**World Forum for Harmonization of Vehicle Regulations****Working Party on Lighting and Light-Signalling****Eighty-eighth session**

**Installation UN Regulations:****UN Regulation No. 48 (Installation of Lighting and Light-Signalling Devices)****Revised proposal for a new series of amendments to UN  
Regulation No. 48****Submitted by the International Association of the Body and Trailer  
Building Industry\***

Figure 1

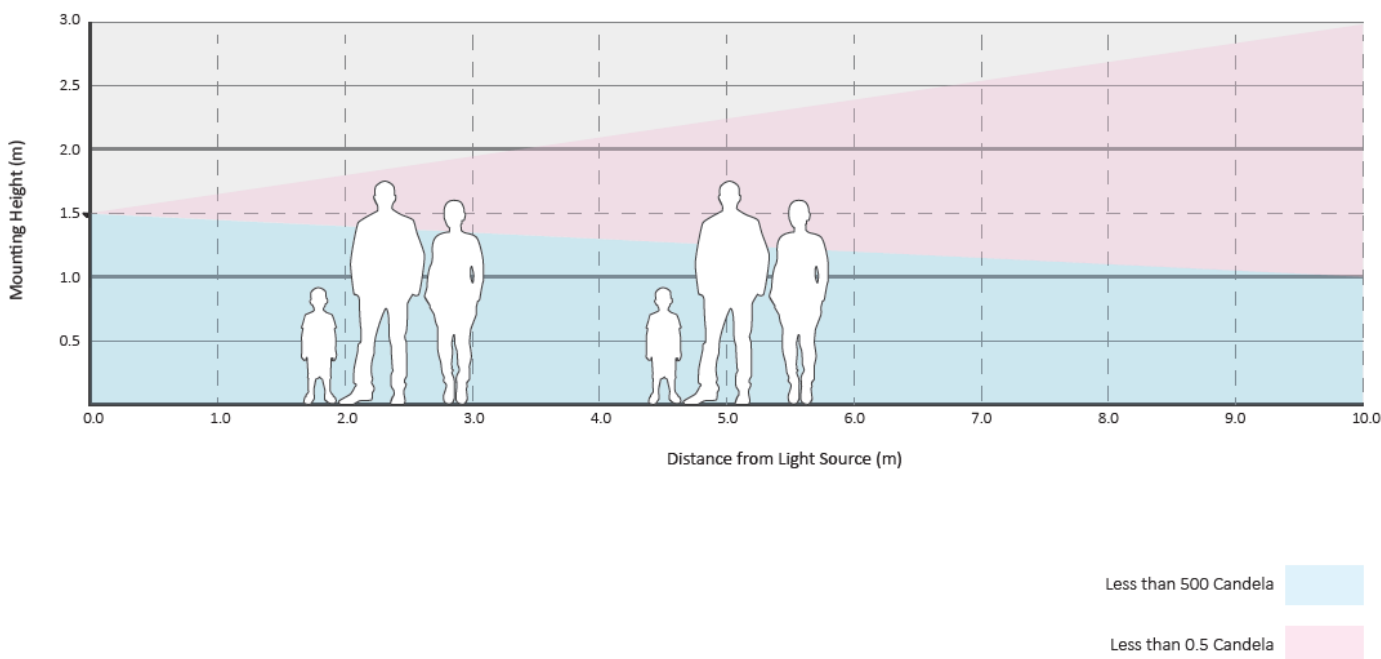
3. As the number of lamps has been increased to a maximum of 3 per side, the installation height has been limited to 1.5 m to avoid the risk of glare to other road users. This also aligns with the maximum height for the installation of side-marker lamps. It should be noted that the observation area of manoeuvring lamps must also meet the requirements of Annex 14 (see Figure 1 below for an illustration of the maximum, worst-case condition).

**6.26.4.2. In height: Above the ground, not more than 1,500 mm.**
